State of New Jersey
DEPARTMENT OF ENVIRONMENTAL PROTECTION

RE: Industrial Establishment: Arsynco
Location: 13th Street, Carlstadt Borough, Bergen County
Block: 91 Lot: 1
Transaction: Cessation of Operations
Remedial Action Workplan Dated: December 31, 2003
ISRA Case #E93024

FIGURE 1 | SCALE: 1" = 120'

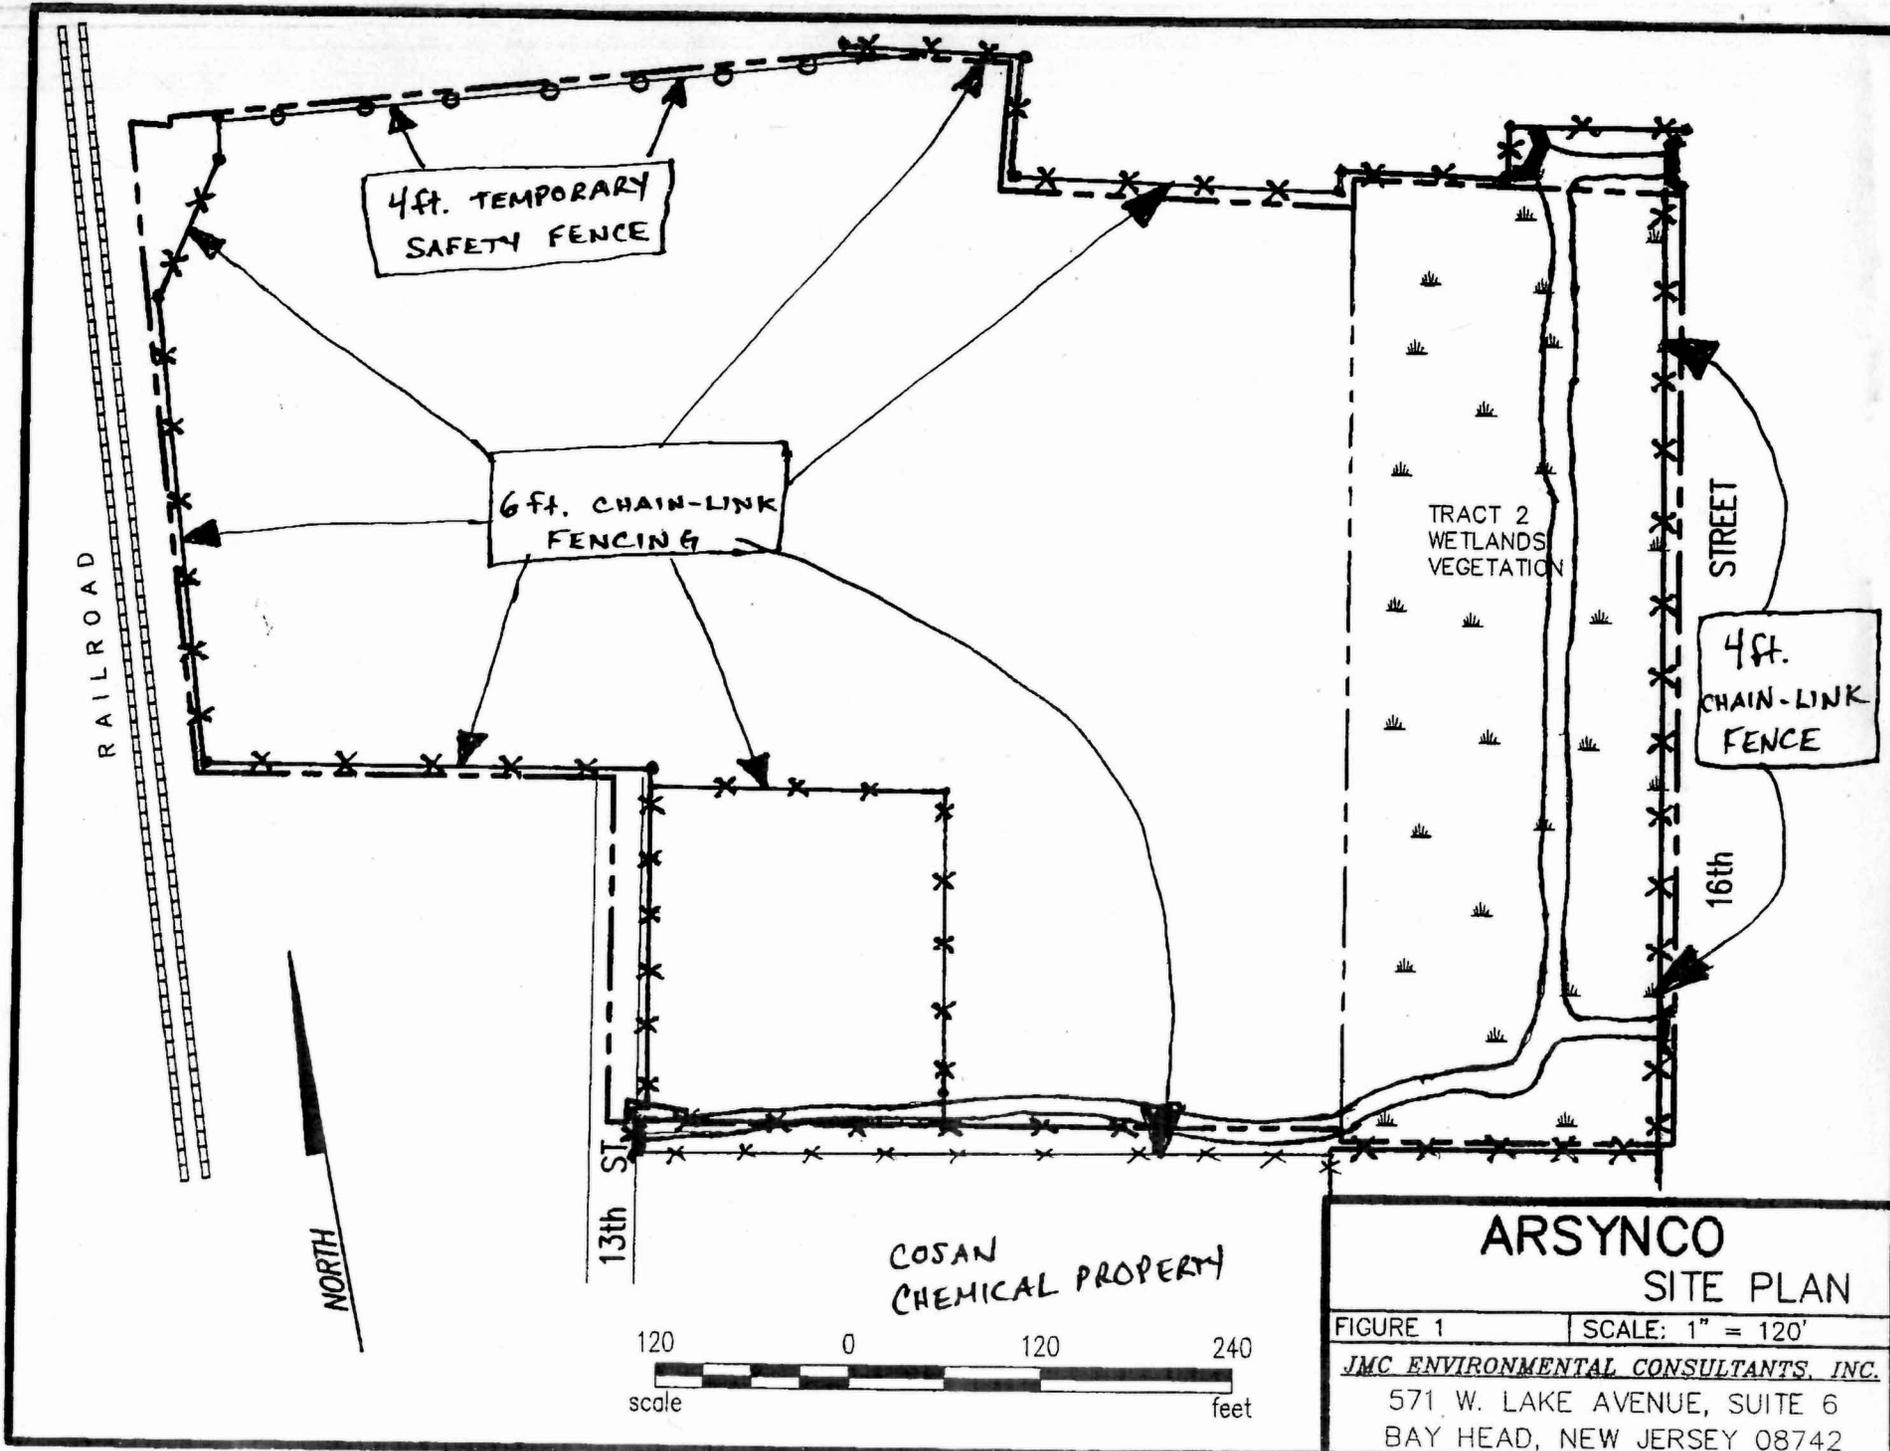
The Arsynco property is currently surrounded by perimeter fencing as shown on the attached site plan. Permanent, 6-foot chain link fencing is present along the entire western property boundary bordering the adjacent railroad tracks. Permanent, 6-foot chain link fencing is also present along the southern property boundary, from the railroad tracks east, all the way to Sixteenth Street. The fencing located along the extreme southern property line is located on both Arsynco's property and on the adjacent property owned by Cosan Chemical; a large, regional, tidal drainage ditch (which always contains water) is also located along this stretch of southern property line. Both the fencing and the drainage ditch serve to prevent unauthorized access to the property in this area.
